UNITED STATES PATENT AND TRADEMARK OFFICE

| APPLICATION NO. | FILING DATE | FIRST NAMED INVENTOR | ATTORNEY DOCKET NO. | CONFIRMATION NO. |
|-----------------|-------------|----------------------|---------------------|------------------|
| 10/660,611 | 09/12/2003 | Chun Ho Fan | 50626.55 | 6110 |

Office Action Summary

DETAILED ACTION

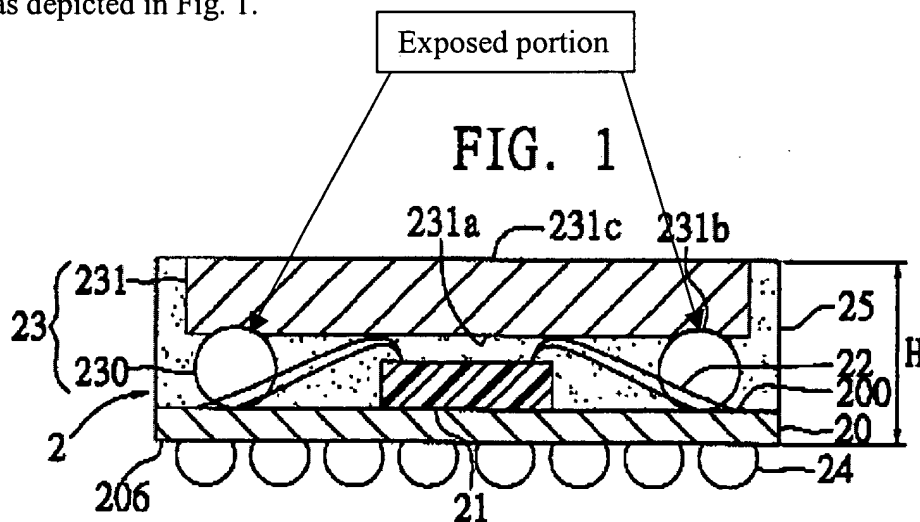
Applicants argue that “Huang et al. certainly fails to teach or suggest the feature of *an overmold material encapsulating said semiconductor die and said balls on said substrate such that portions of said balls that are disposed farthest from said substrate are exposed at an exterior of said Integrated circuit package...*”

In response to applicants’ contention, it is respectfully submitted that Huang et al. ’0113308 disclose all the claimed limitations including “overmold material encapsulating said semiconductor die and said balls on said substrate such that portions of said balls that are disposed farthest from said substrate are exposed at an exterior of said Integrated circuit package,” as depicted in Fig. 1.

As shown above, the exposed portion of the balls 230 is at exterior portion of the package which is farthest from the substrate 20. In addition the heat sink 231 is in contact with the exposed portion of balls 230 and the overmold material 25 also encapsulating the semiconductor die 21 and the balls 230. Furthermore, the semiconductor die 21 is electrically connected to solder balls 24 for external connection via through conductive traces 22 (see Page 2, Paragraph 0024).

Therefore, the rejection of claims 13, 15- 17, 20-22, 24 and 25 under 35 U.S.C. § 102(b) is deemed proper. In addition, the rejection of claim 23 under 35 U.S.C. § 103(a) is deemed proper and the *prima facie* case of obviousness has been met.
